TEST SPECIFICATION: FCC part 2, §2.987 (b), part 22, §22.915(c)
COMPANY: Telrad
EUT: CET-10
DATE: September 28, 1998
RELATIVE HUMIDITY: 51%
AMBIENT TEMPERATURE: 22°C

RE: Your E-mail dated August 4, 1998; correspondence ID: 2429

Subject: FCC ID: ARACET-10, Application for type acceptance of digital radio telephone, applicant Telrad Telecommunication and Electronic Industries Ltd.
731 Confirmation Number: EA89412

3. Please find the frequency stability test data down to -30°C (corrected page 44 of Test Report TLRFCC.12663, Attachment #3, 9 plots – frequency stability, 6 plots – output power).

AUG 26 '98 16:33 HERMON LABS

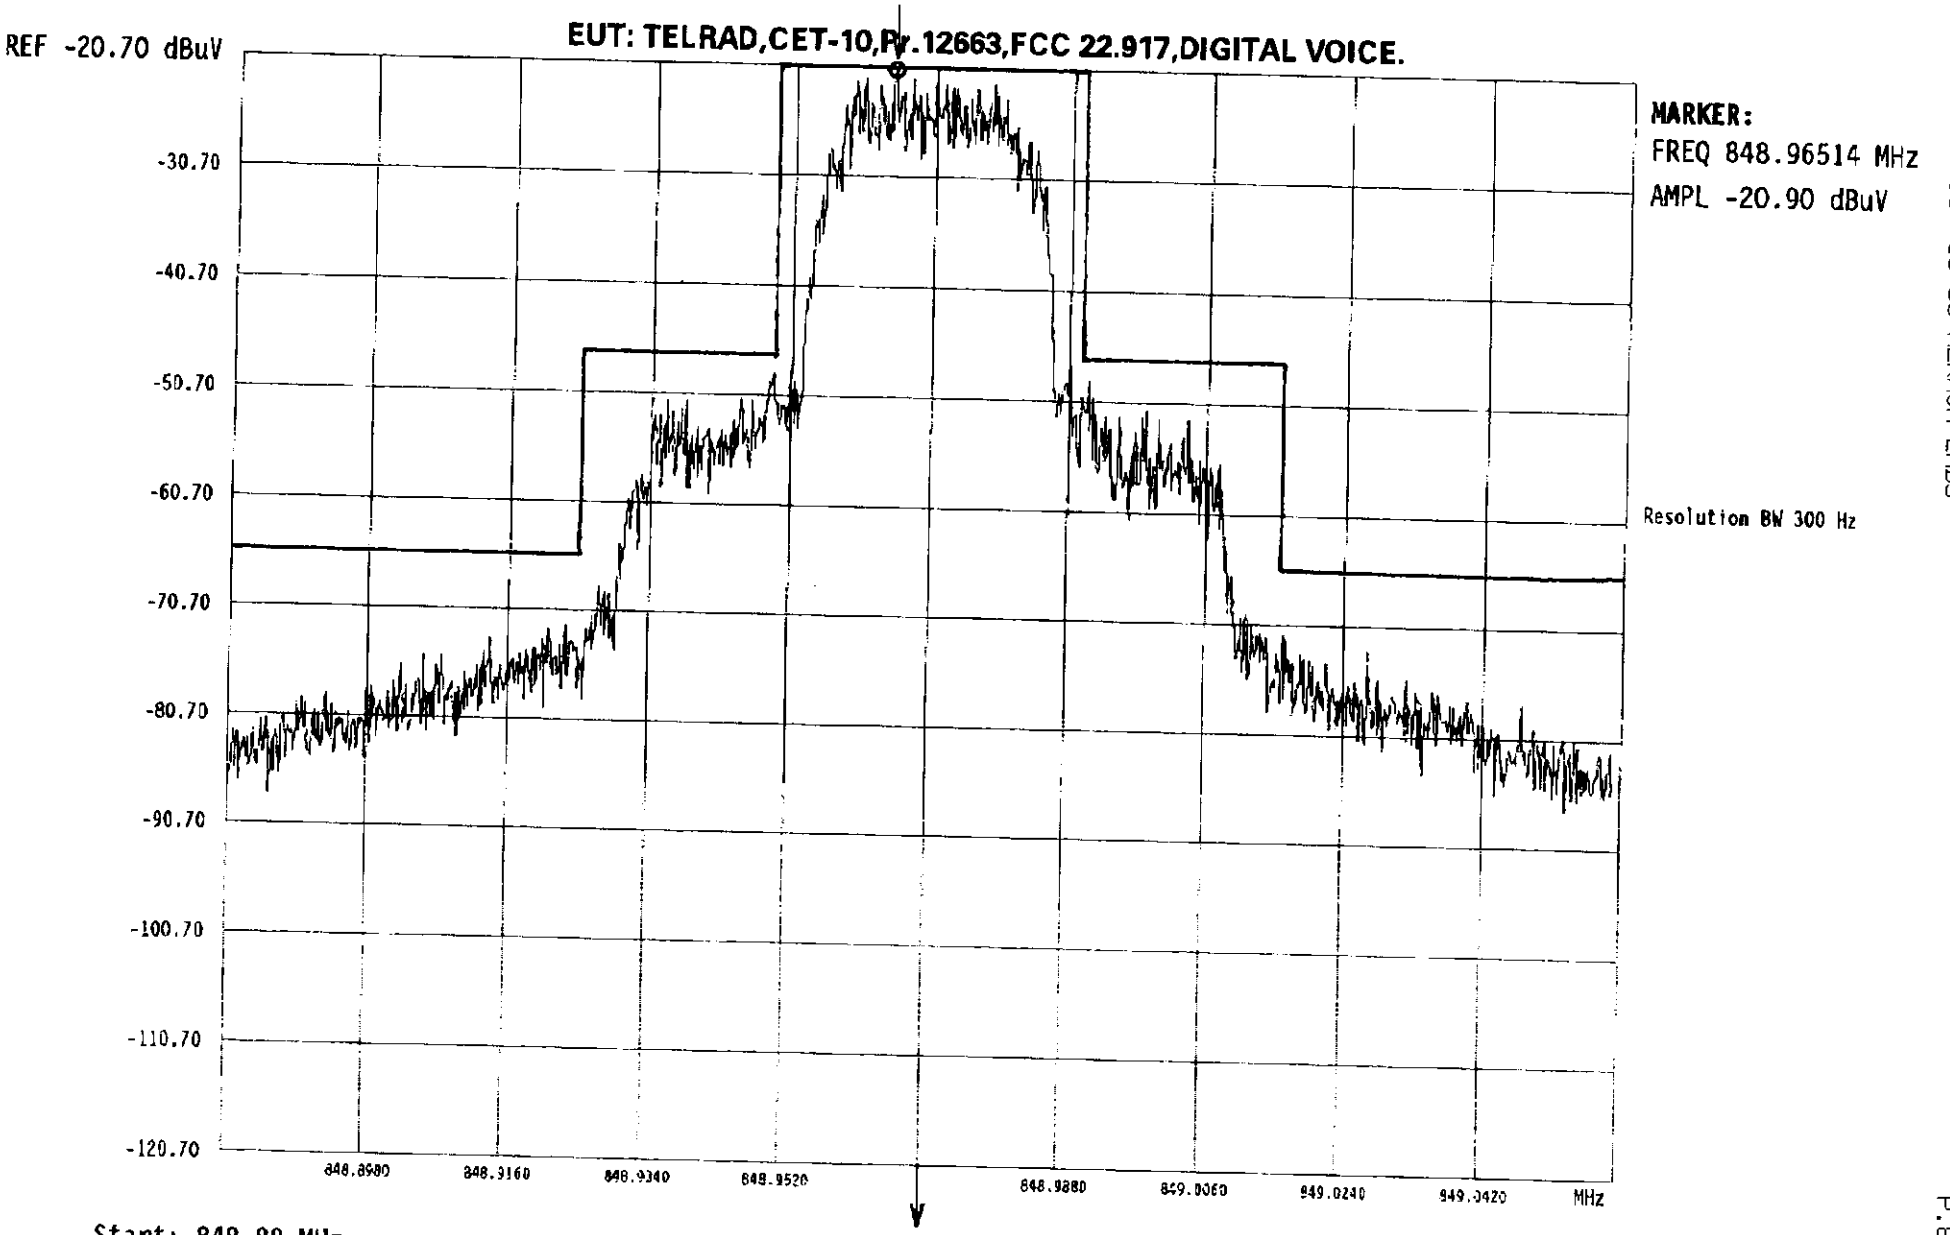
1. Please find the test results according to F1D basic characteristics (Attachment #1, 6 plots).

## Frequency Stability Over Temp. Range

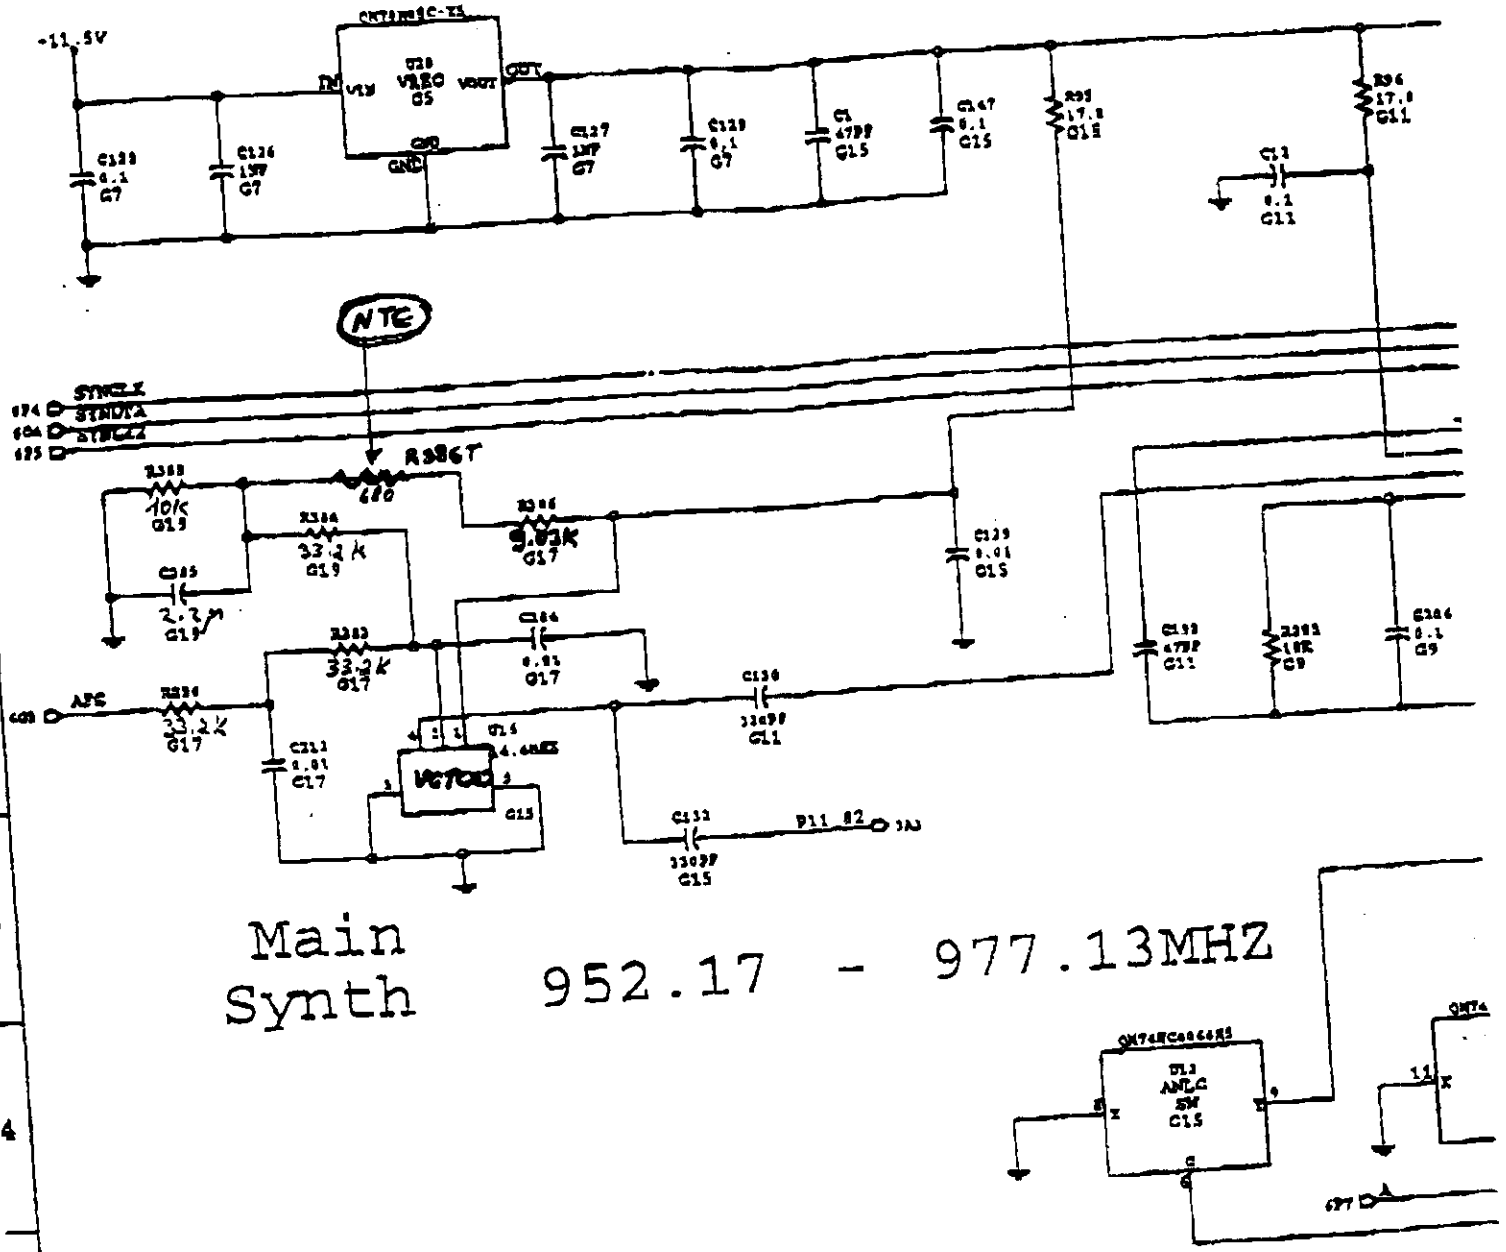
The temp. stability is +-2 ppm over 0 to +65 C.
In order to improve temp. stability we have compensated the original VCTCXO control voltage by addition of negative temp. coefficient (NTC) resistor in serial to R386 in the voltage divider. (see enclosed scheme).

The NTC resistor has an opposite behavior graph to the VCTCXO.
The result is a significant improvement . Enclosed is the result with the compensation over the temp. range: -30 to +40 C.
